REVISIONS

RENO, NEVADA
FEBRUARY, 2025

PRELIMINARY CROSS SECTIONS EXHIBIT PLUMAS REDEVELOPMENT

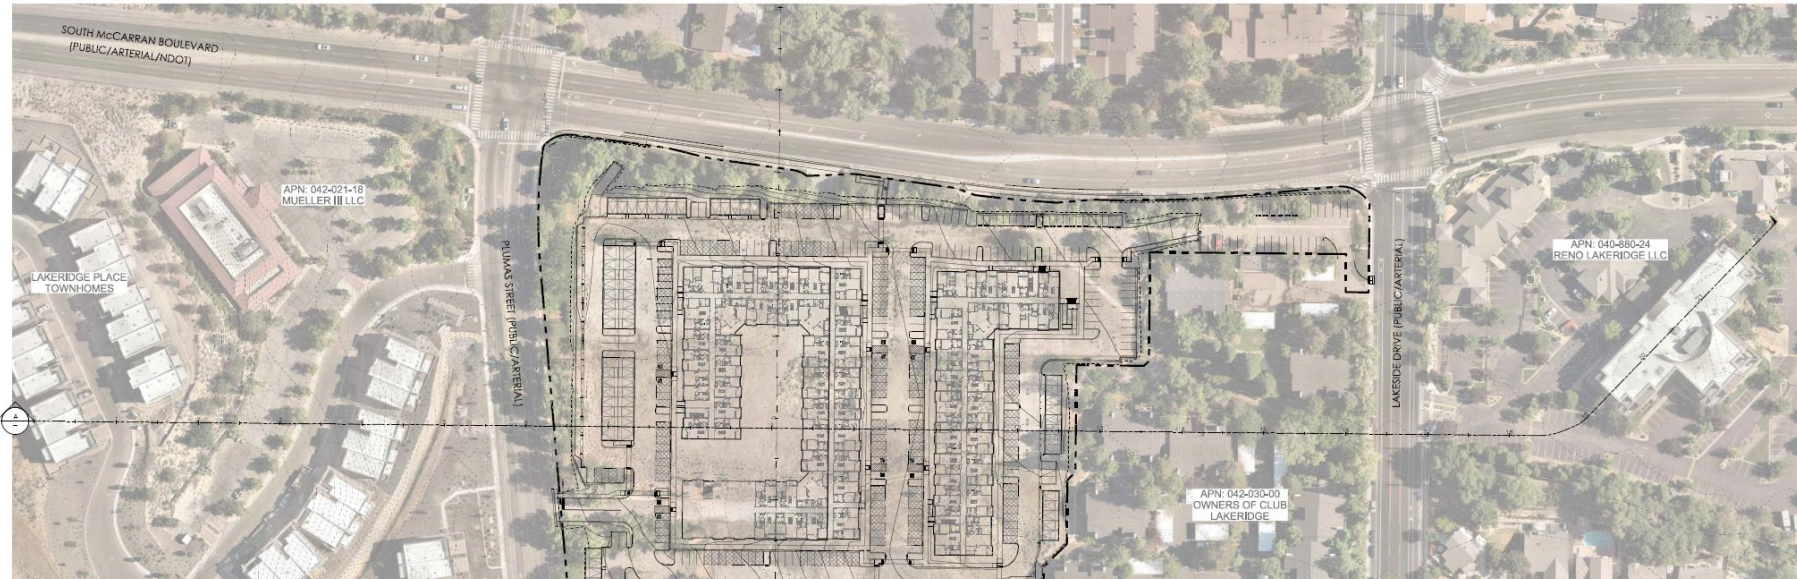
- **Roofline** – Requested more vertical and horizontal articulation
 - Opening up balconies did much of the work here
 - We've also added in roof / parapet projections
- **Massing** – Requested more articulation, particularly at corners
 - Opening up balconies achieved the desired look
- **Colors** – Requested lighter colors up top, darker base
 - Omitted the darker stucco colors altogether in response to feedback previously
- **Balconies** – Requested to open up, particularly at corners
 - Substituting faux wood siding and wood tone colors where we've opened up balconies
